Statesville Office (704) 878-5305 | Mooresville Office (704) 660-3625 | PERMIT # 244684

SEPTIC IMPROVEMENT PERMIT / AUTHORIZATION TO CONSTRUCT / OPERATION PERMIT / EXISTING SYSTEM

APPLICANT/OWNER: Susan Halliday/CsandSC | APPLICANT ADDRESS: 164 Hickory Hill Rd Mooresville, NC 28117

SOIL/SITE EVALUATION
for ON-SITE WASTEWATER SYSTEM
(Complete all fields in full)

FLOOR PLAN - MAIN FLOOR

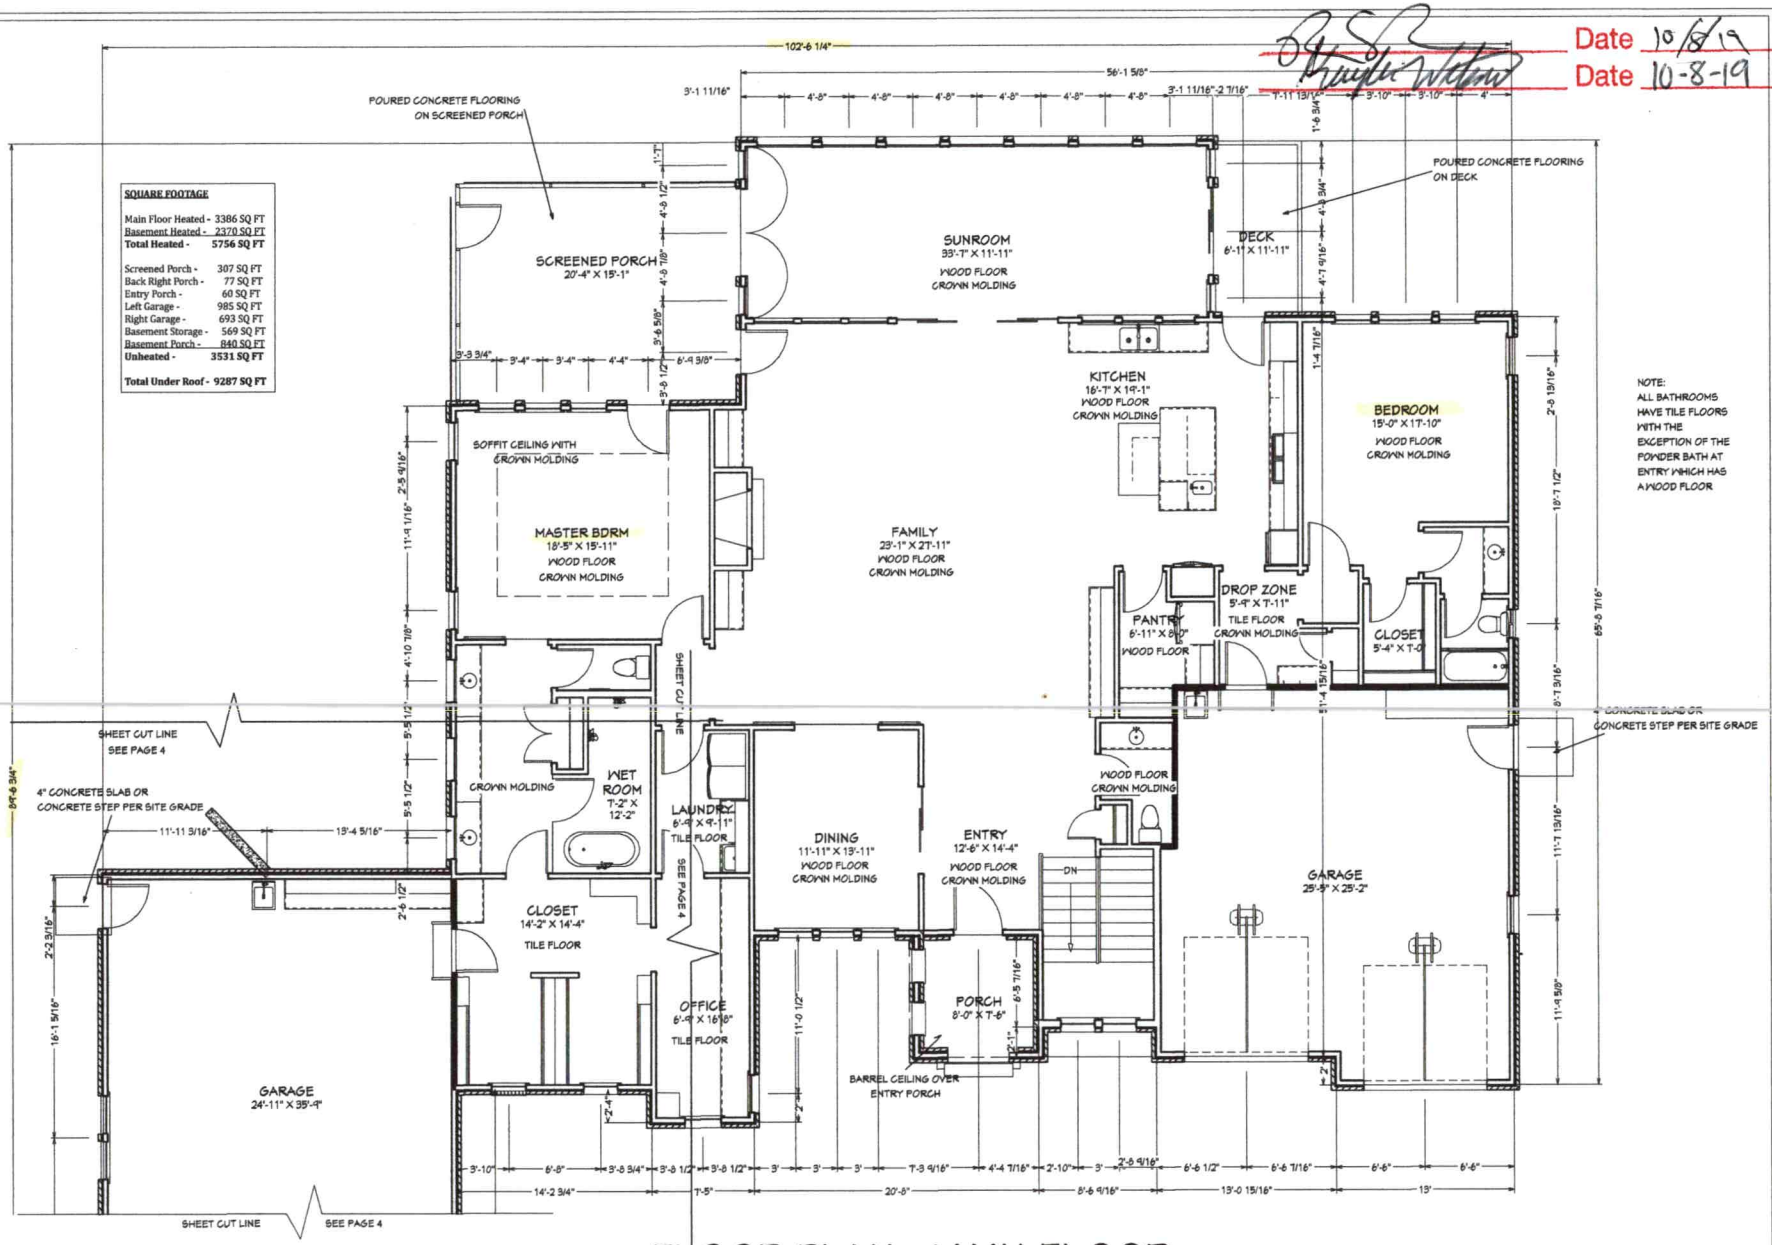
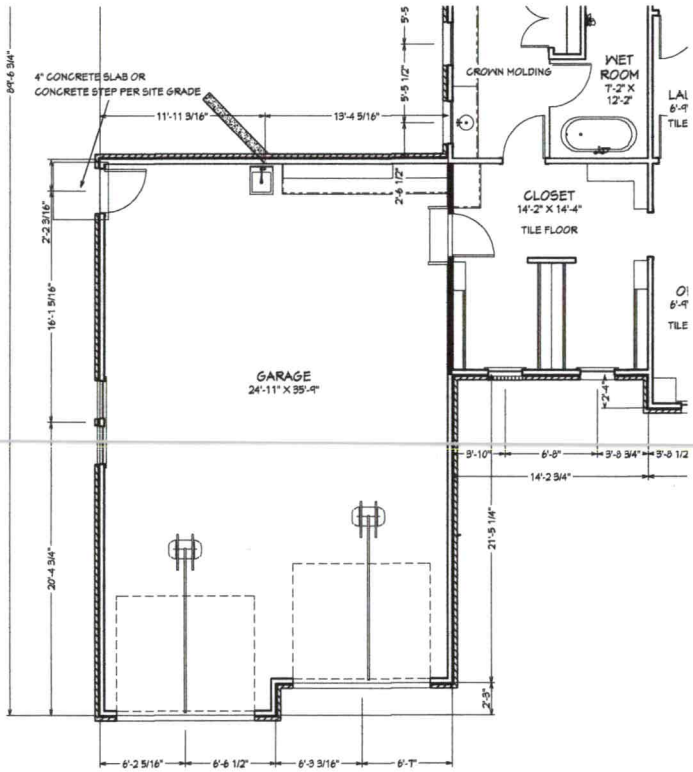
For Existing drainfield Use 1" Sch 40 taps
For New Drainlines being added Use 1¼" SCH80 Taps
* Floor plans submitted are 1' longer (in depth). OK as long as extra 1' is built toward back of property.
